# Road & Bridge Design Publications

## Monthly Update – January 2026

Revisions for the month of **January** are listed and displayed below and will be included in projects submitted for the **May** letting.

STANDARD PLAN FOR  
BRIDGE BARRIER RAILING, TYPE 7

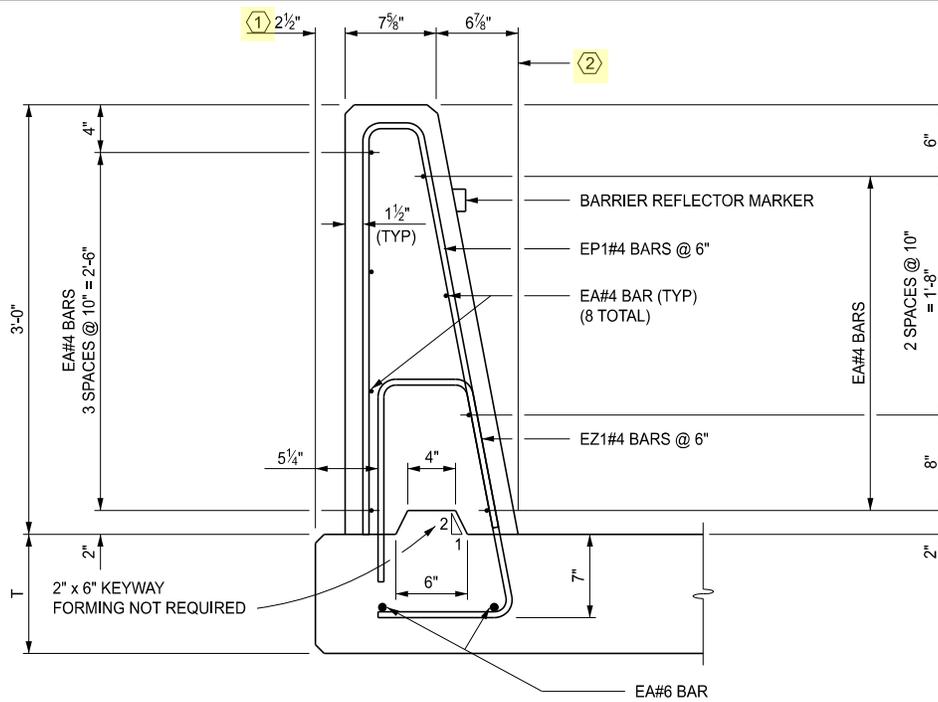
Removed Bridge Barrier Railing, Aesthetic Type 7, Det 1 railing.

STANDARD PLAN FOR  
BRIDGE BARRIER RAILING, TYPE 6

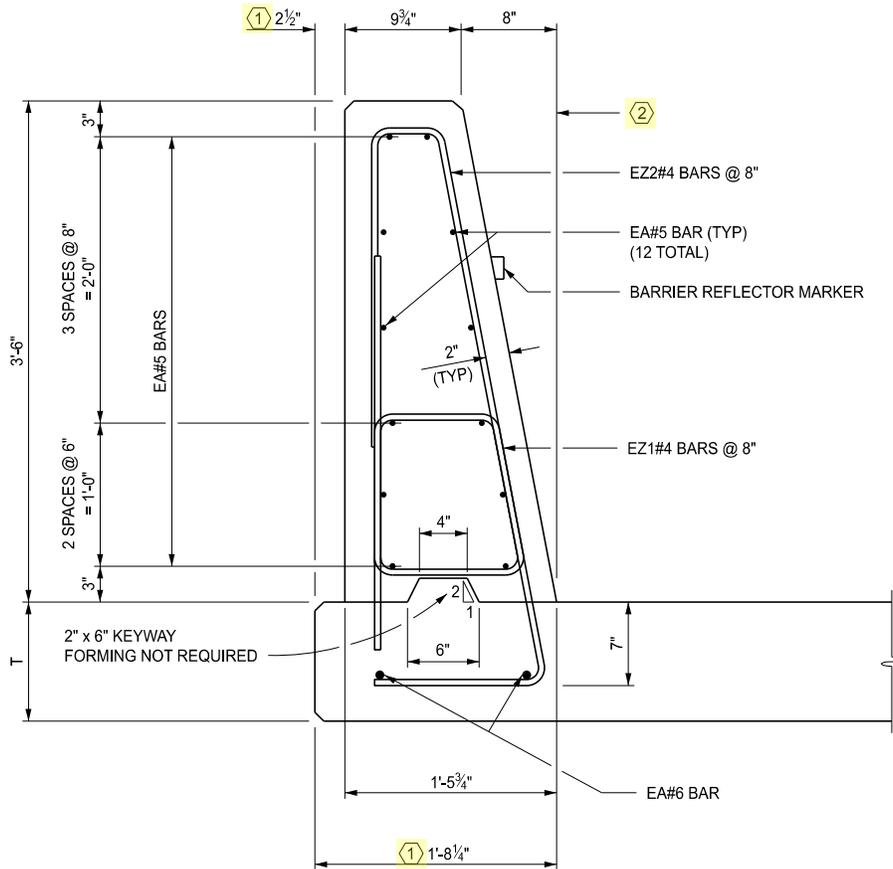
Removed Bridge Barrier Railing, Aesthetic Type 6, Det 1 railing.

STANDARD PLAN FOR  
FENCING FOR BRIDGE RAILING,  
AESTHETIC PARAPET TUBE

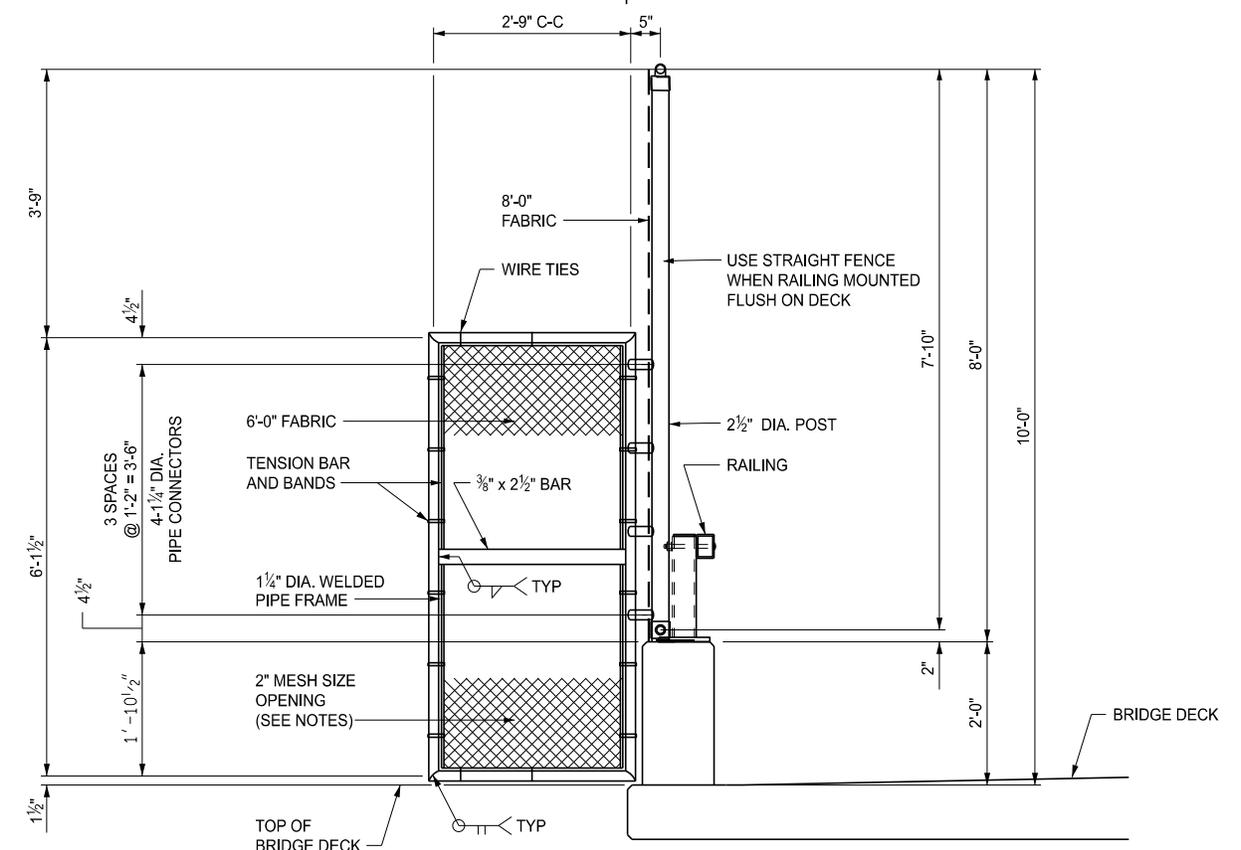
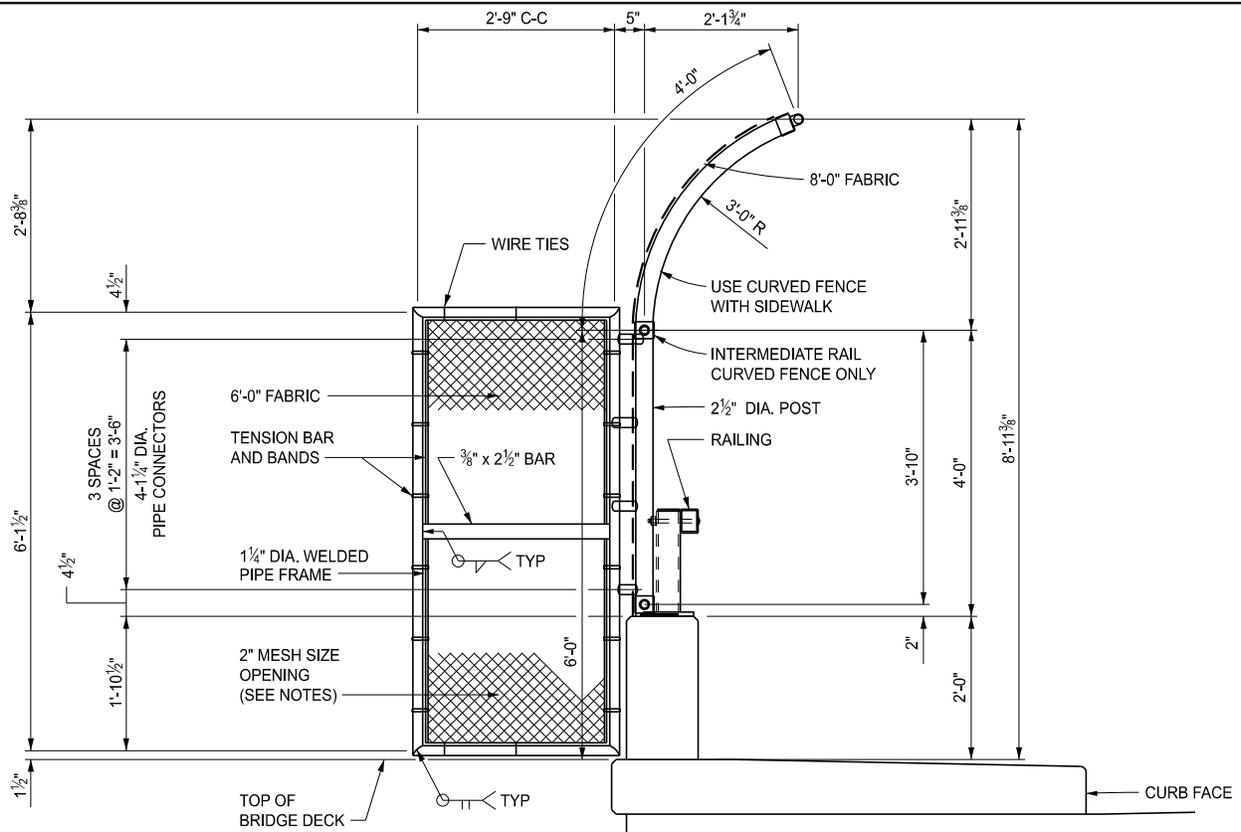
Added elastomeric leveling pad below fence post base plates and revised anchor bolt projection length. Updated font for ADA requirements and revised notes to active voice.

**6.29.10**

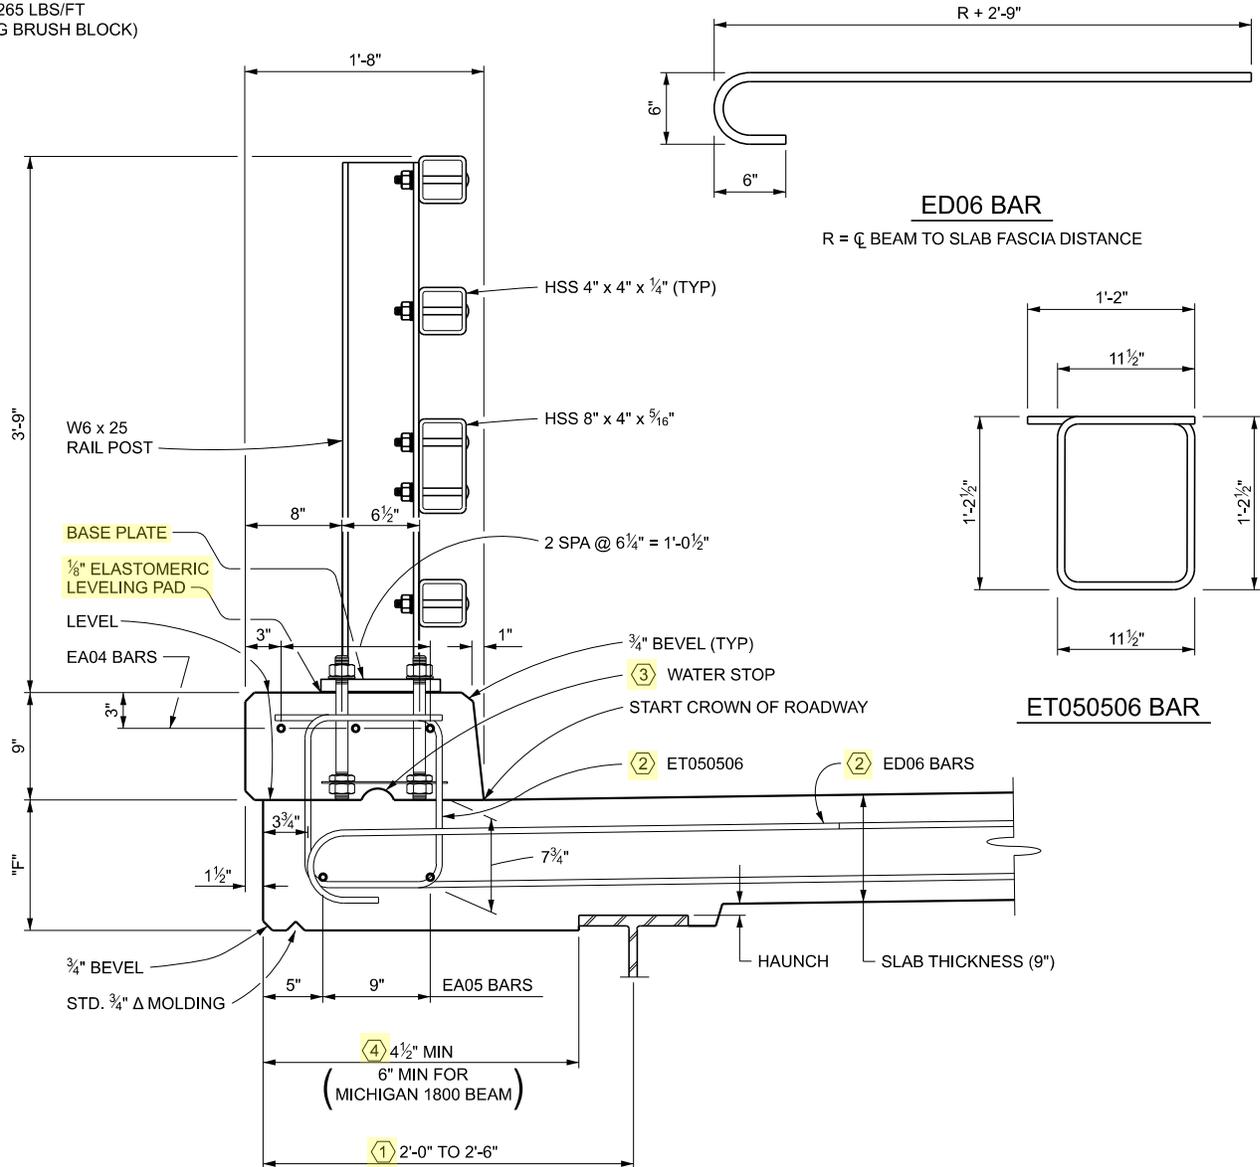
Added elastomeric leveling pad below railing posts. Updated font for ADA requirements and revised design guide note designations. Added note to provide information related to the location of the screed rail and railing reinforcement. If a minimum of 1'-0" of clearance does not exist between the centerline of the fascia beam and railing reinforcement, designers are to contact BOBS Bridge Construction to discuss alternative screed rail options.

- ① IT IS PREFERRED TO PROVIDE A MINIMUM OF 1'-0" OF CLEARANCE FROM THE EL BARS TO THE FASCIA BEAM CENTERLINE TO PERMIT SUPPORT OF THE SCREED RAIL ALONG THE TOP OF THE FASCIA BEAM. IF SUPERSTRUCTURE GEOMETRY DOES NOT ALLOW FOR THIS 1'-0" MINIMUM DISTANCE, ALTERNATE SCREED RAIL SUPPORT METHODS MAY BE REQUIRED. IF THIS SCENARIO APPLIES, CONTACT BOBS BRIDGE CONSTRUCTION TO DISCUSS ALTERNATE SCREED RAIL OPTIONS, BRIDGE DECK FINISHING OPTIONS, AND PROPOSED SUPERSTRUCTURE CONSTRUCTABILITY.
